**Eighth Interim Collection
1997–1999 NESC® Interpretations**

**Eighth Interim Collection
of the
National Electrical Safety Code®
Interpretations
1997–1999**

Abstract: This edition includes official interpretations of the National Electrical Safety Code as made by the Interpretations Subcommittee of the National Electrical Safety Code Committee, ASC C2.

Figure 1—Typical wood transmission structure with distribution underbuild

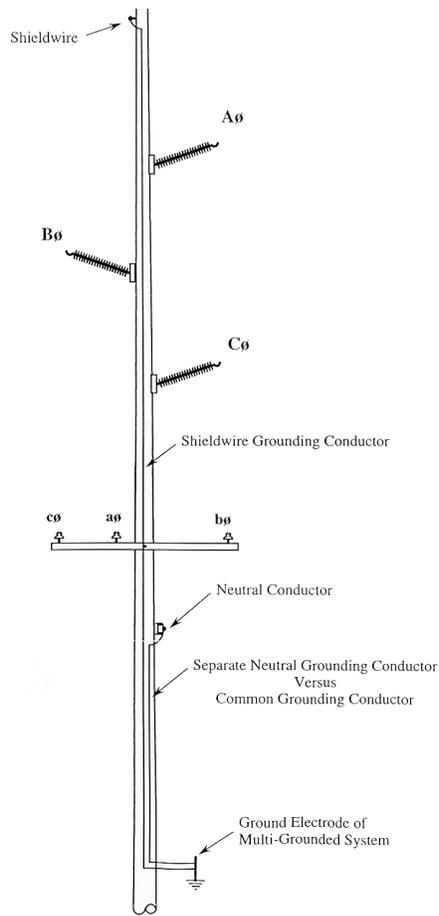
- a) Is the grounding conductor for a lightning shield wire addressed by this rule?
- b) Is a lightning shield wire considered to be like a “surge arrester” and, thereby, to be considered under Rule 97A1?
- c) Can a common grounding conductor be utilized between a transmission shield wire, multi-grounded distribution primary neutral, lightning surge arresters, pole mounted equipment grounds, secondary neutral, and the grounding electrode? (See Figure 1.) Is this practice permitted under Rule 97B?

I, along with my associates, opine that using a single interconnected grounding conductor is a safe practice. Conversely, providing separate grounding conductors between the shield wire and the system’s neutral will not prevent a lightning surge from flashing over to the system neutral.

The answer to question a) is: Rule 97 does not specifically cover grounding conductors for a transmission circuit shield wire.

The answer to question b) is: Such shield wires are not like surge arresters for Code purposes. Rule 91, which covers the scope of the grounding rules, states: "These rules do not cover the grounded return of...those lightning protection wires that are normally independent of supply or communication wires or equipment." However, see IR 476 for shield wires intentionally designed to serve both as a shield wire and as a neutral conductor.

The answer to question c) is: A common grounding conductor as described in your question is not prohibited, provided that all requirements for a common grounding conductor are met. See also Rule 012 regarding good practice for particulars not specified in the NESC rules.

Figure 2—PCS antenna, pole top assembly

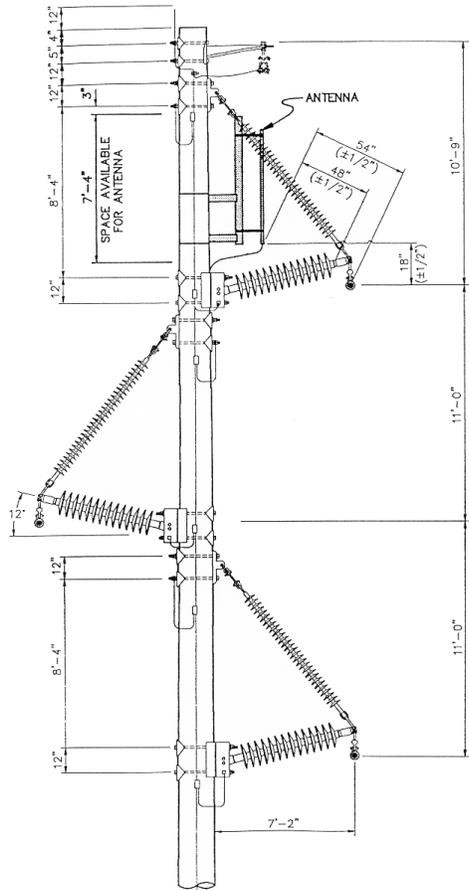
I am unable to find a rule in the National Electrical Safety Code, 1993 or 1997 Edition, that specifically addresses clearance to communication antennas attached to supply company structures mounted (see Figure 2) in the supply space. Our present interpretation would be Rule 235 and Table 235-6. Any work would be performed by persons qualified to work in supply space while electric power line is de-energized. Since Rule 235 and Table 235-6 establish the minimum

clearance between a conductor and the steel transmission pole to which it is attached, we find this clearance the only appropriate clearance to use. The line voltage is 230 kV, therefore; the calculation is $[11 \text{ in} + (230 - 50) \times 0.2 \text{ in}] = 47 \text{ in}$.

Rule 224A2c addresses clearance to open wire communication circuits in the supply space, but is incomplete in that it does not address clearance to pole mounted communication antennas in the supply space.

I would greatly appreciate an interpretation of either rule as one or the other would apply to these recently introduced pole mounted communication antennas.

You are correct; the NESC does not contain specific rules covering clearance for communication antennas installed in the supply space of supporting structures. Consequently, Rule 012 applies. Nevertheless, the Interpretations Subcommittee believes that some comments regarding your assumptions and calculations are in order.

As you surmised, Rule 235 and Table 235-6 provide the best guidance in this situation. Table 235-6 specifies clearance requirements from line conductors to vertical conductors. While the antenna is not a vertical conductor as the term is normally used in the NESC, the antenna functions as a rigid, vertical, open wire, communication conductor. Also, the lead to the antenna is a communication conductor. Rule 224A2c requires open wire communication circuits in the supply space to have the same clearances from supply circuits as would be required for open supply conductors of 0–750 V. However, the maximum voltage of the antenna should be obtained from the manufacturer or supplier of the broadcasting system because a higher voltage may be appropriate.

In applying Table 235-6, the clearance between two different circuits (supply and communication) must be determined. Consequently, item 1b is appropriate (the second line of the table), with the clearance as stated in the last column (supply lines over 50 kV), rather than item 4b as you used in your example (the antenna is not a surface of the supporting structure). All appropriate footnotes, including 4, 9, and 12, also must be considered.

Another concern is degradation of the flashover characteristics of the structure if an antenna is introduced between the structure and an energized high-voltage conductor as shown in your drawing. If flashover occurs due to over-voltage, the flashover should go to the structure, not to the antenna and/or its related circuit. Considering the good practice required by Rule 012, the air gap clearance between the antenna and the nearest energized conductor should exceed the equivalent dry arcing distance of the shorter (or lesser insulating) string of insulators by an appropriate amount to assure flashover to the structure.

Finally, you state that any work (on the antenna assembly) would be performed by persons qualified to work in the supply space while the electric power line is de-energized. We are not sure of what you mean by "de-energized": disconnected (from all sources of electric supply) or disconnected and grounded. Normally, the line would be de-energized and grounded, otherwise live line work practices with associated greater clearance distances would be required to work on the antenna. In either case, the workers must be fully qualified to work both in the supply space under the appropriate work practice and on the antenna itself.
